State of Alaska  
Department of Fish and Game  
Sportfish Division

Nomination Form  
Anadromous Waters Catalog

Anadromous Waters Catalog Number of Water Body 330-00-10850-2210 (-0010) and (-0020)

Nomination #	<u>24-744</u>	<u>Adam Raimo</u>	<u>5-1-2024</u>
		Fisheries Scientist	Date
Revision Year:	<u>2025</u>	<u>Ryan Benhart</u>	<u>5/1/2024</u>
		Habitat Operations Manager	Date
Revision to:	<input checked="" type="checkbox"/> Atlas	<u>Emily Miller</u>	<u>2 April 2024</u>
	<input checked="" type="checkbox"/> Catalog	AWC Project Biologist	Date
Revision Code:	<u>C-8</u>	<u>T. O.</u>	<u>5/13/2024</u>
		GIS Analyst	Date

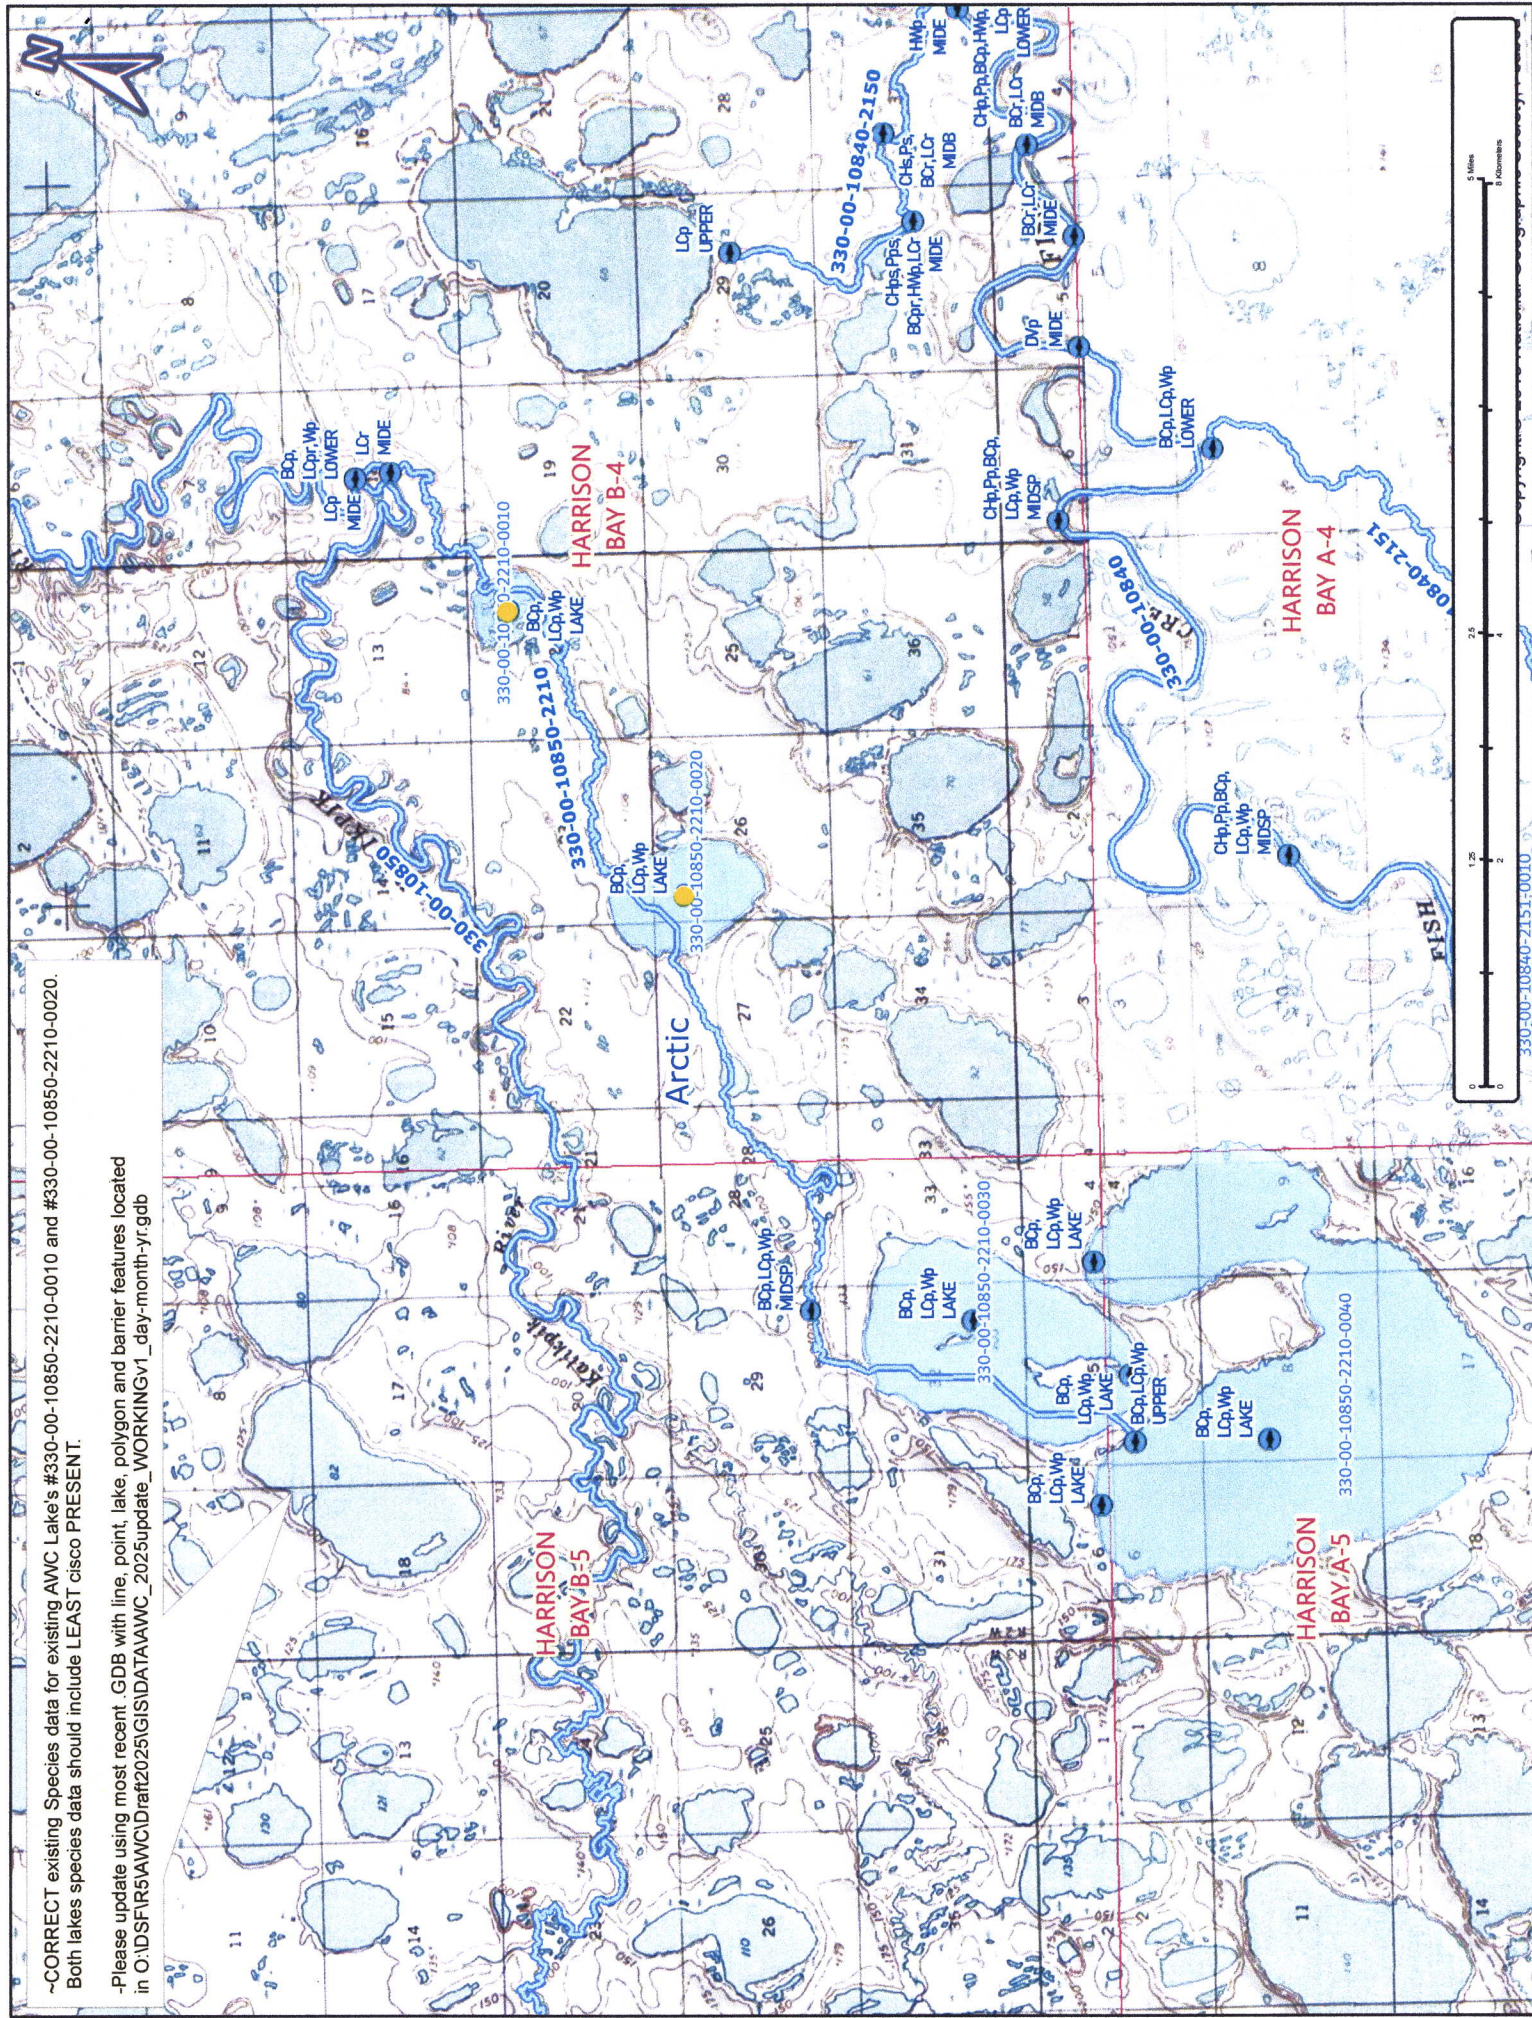
~CORRECT existing Species data for existing AWC Lake's #330-00-10850-2210-0010 and #330-00-10850-2210-0020.  
Both lakes species data should include LEAST cisco PRESENT.

-Please update using most recent .GDB with line, point, lake, polygon and barrier features located  
in O:\DSFIR5\AWC\Draft2025\GIS\DATA\AWC\_2025update\_WORKING\1\_day-month-yr.gdb
